**FINAL ENGINEERING PLANS
FOR
SUMMIT HOUSING GROUP - MULTIFAMILY SITE**

TRACT A, BLOCK 3

LYONS VALLEY PARK FILING NO. 8

COVER SHEET
SUMMIT HOUSING GROUP
LYONS VALLEY PARK FILING NO. 8
LYONS, COLORADO

WATER PLAN AND PROFILE
SUMMIT HOUSING GROUP
LYONS VALLEY PARK FILING NO. 8
LYONS, COLORADO

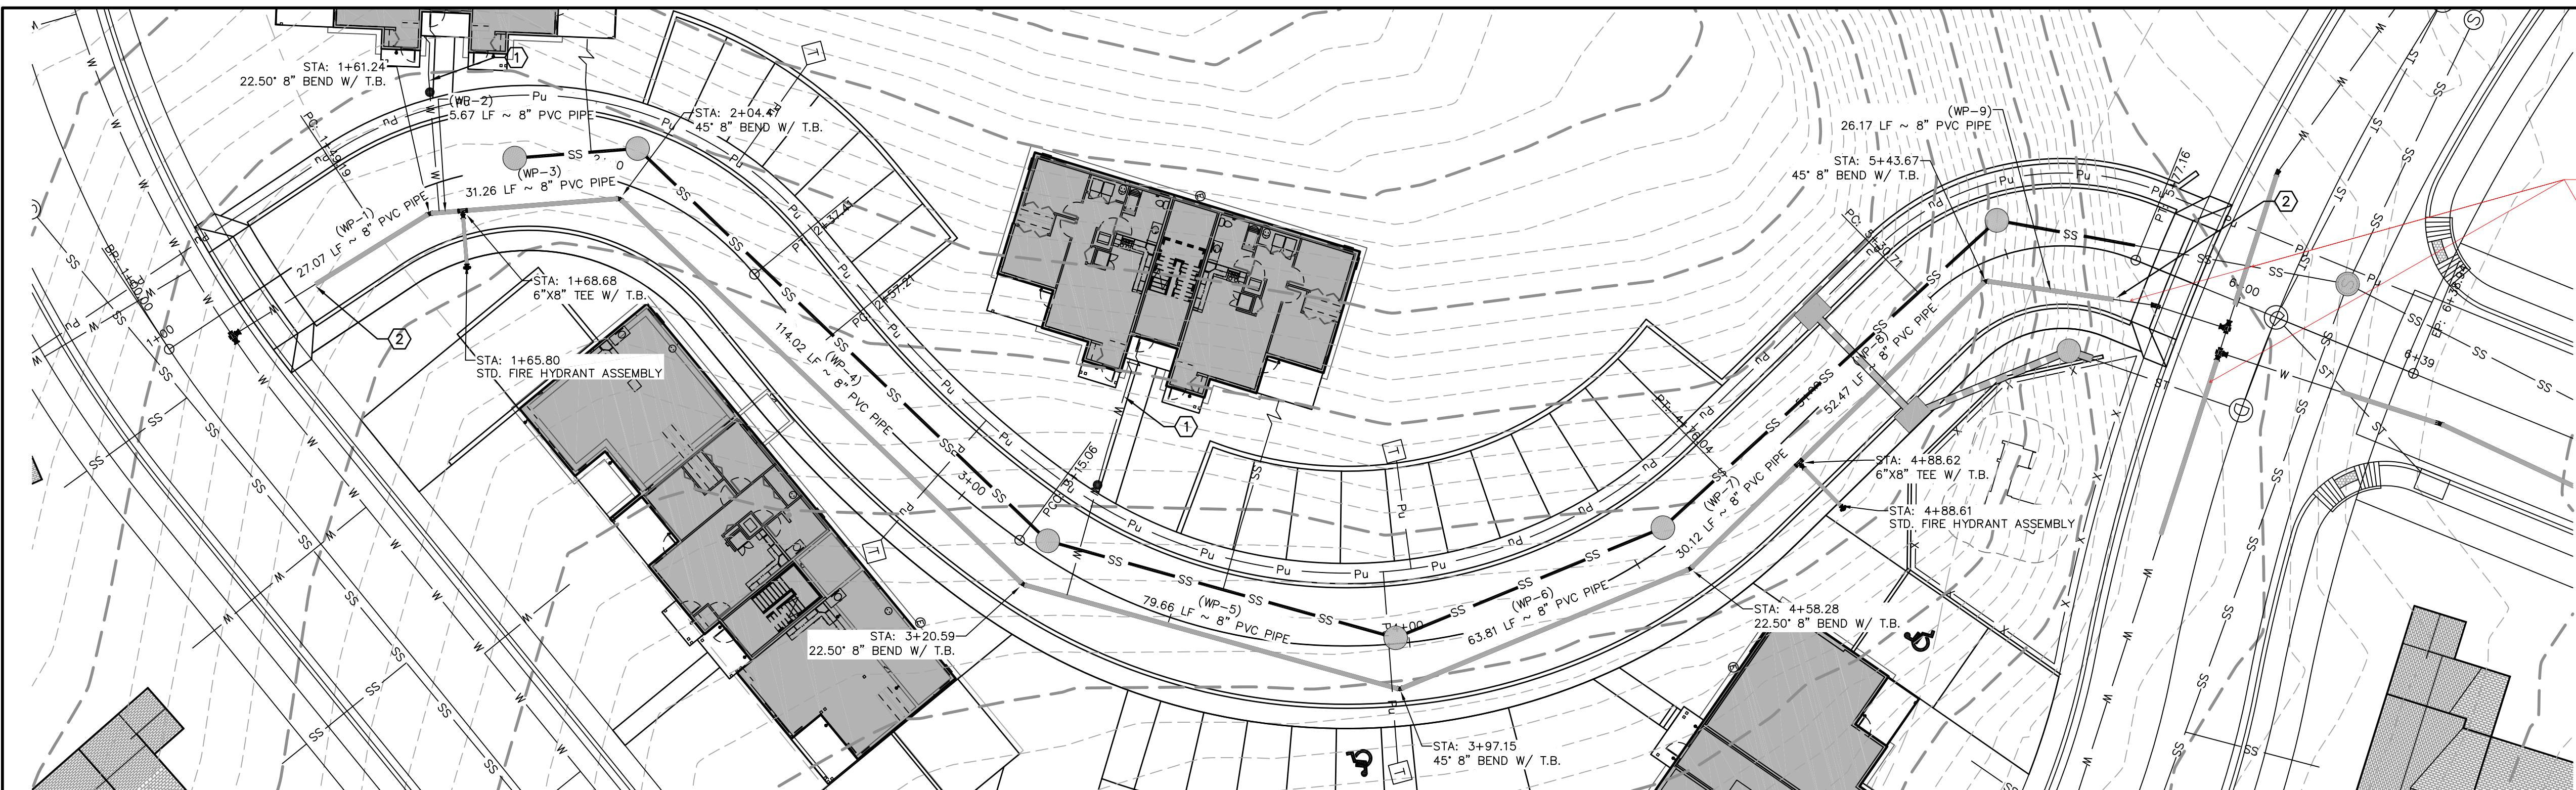
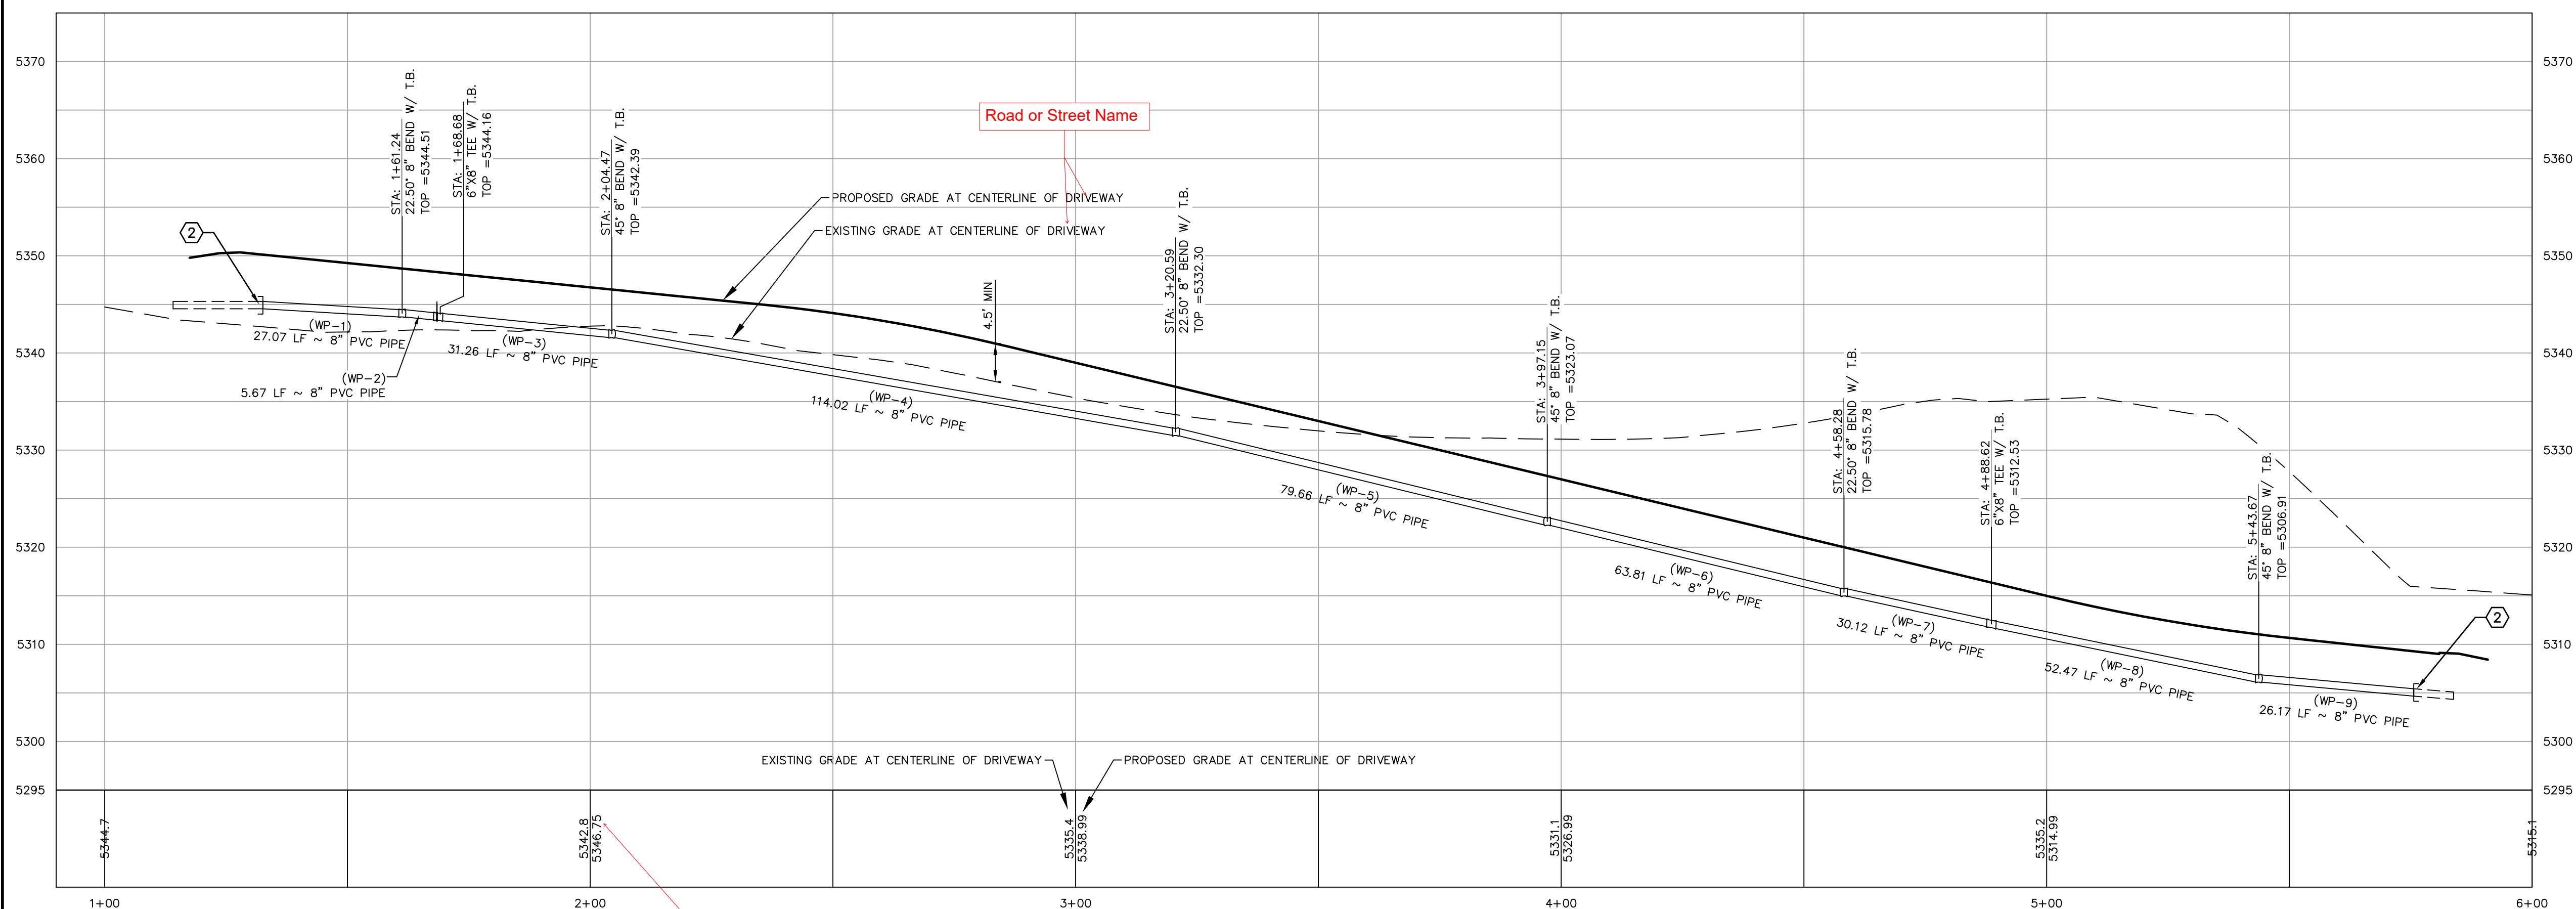
The Town of Lyons Water Distribution System Construction Design Standards state that water mains must have a minimum of 4.5 feet and a maximum of 6 feet of cover from finished grade directly above the pipe to the top of the pipe. Please show the proposed grade at the centerline of the water line with the required clearance or label the points of minimum and maximum cover on each profile to demonstrate that minimum and maximum cover are not exceeded.

1 STORM SEWER PROFILE
SCALE: HORIZONTAL: 1"=20'
VERTICAL: 1"=5'

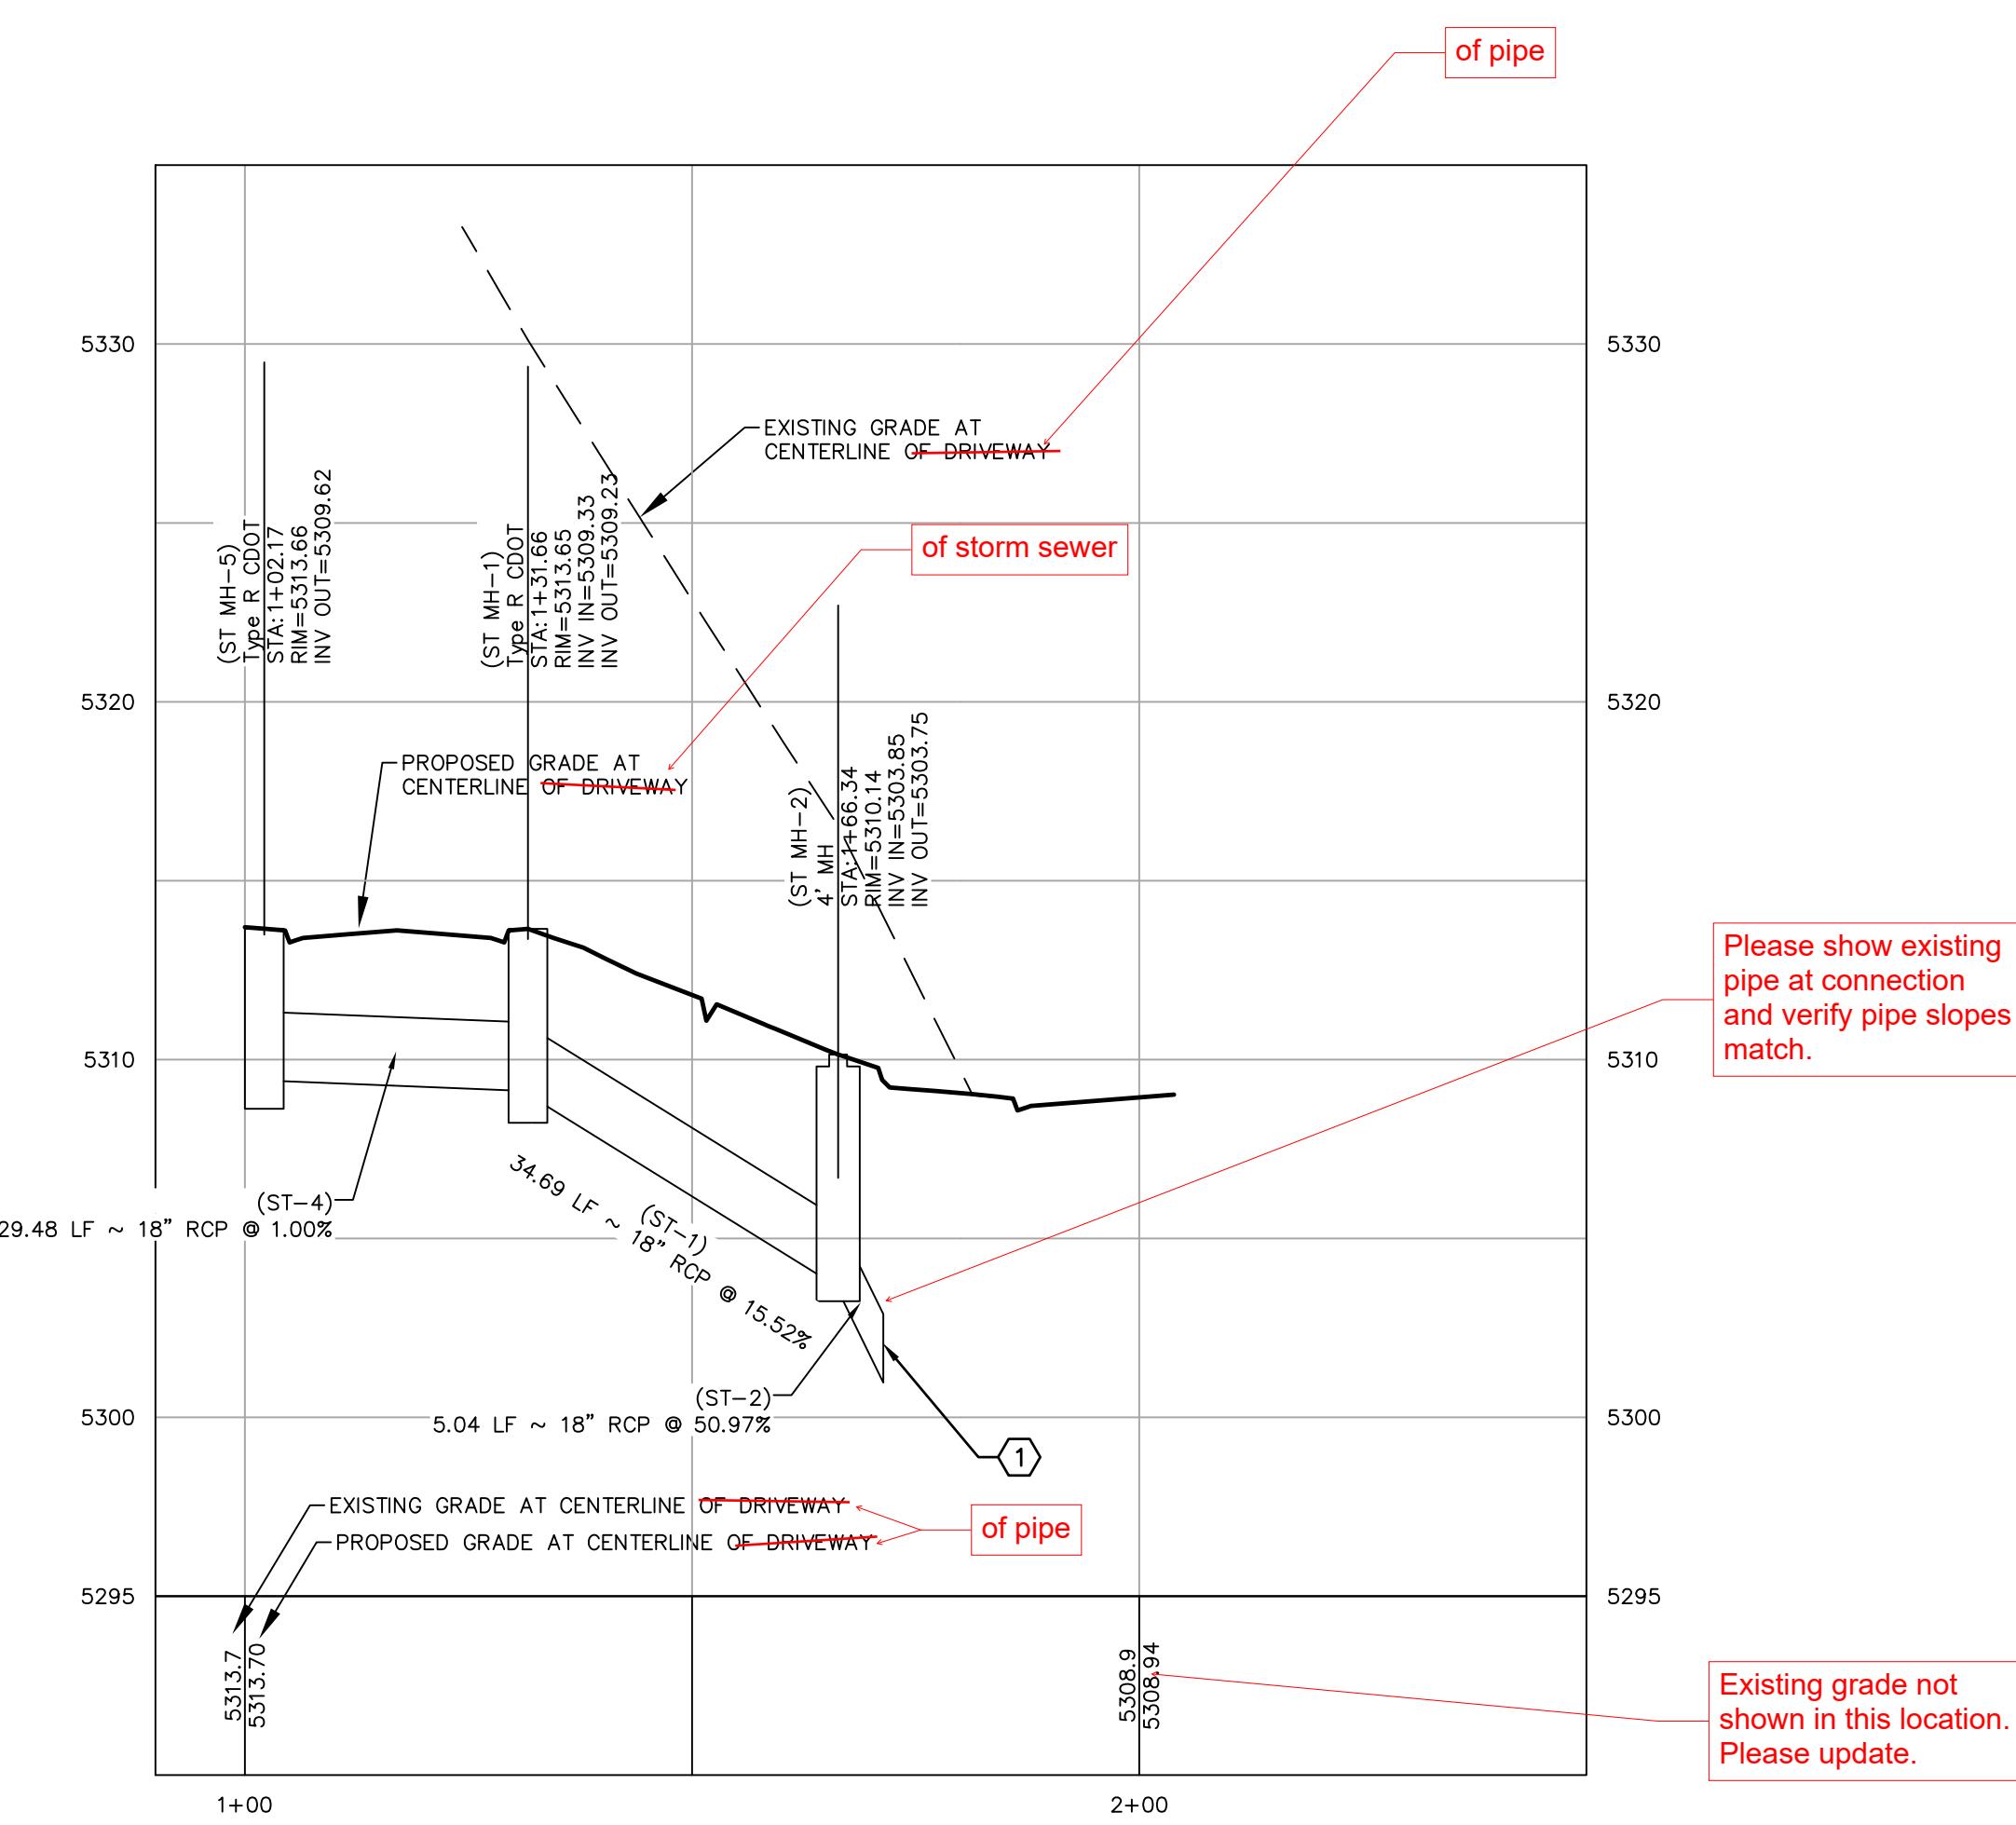
Existing grade not shown in this location.
Please update.
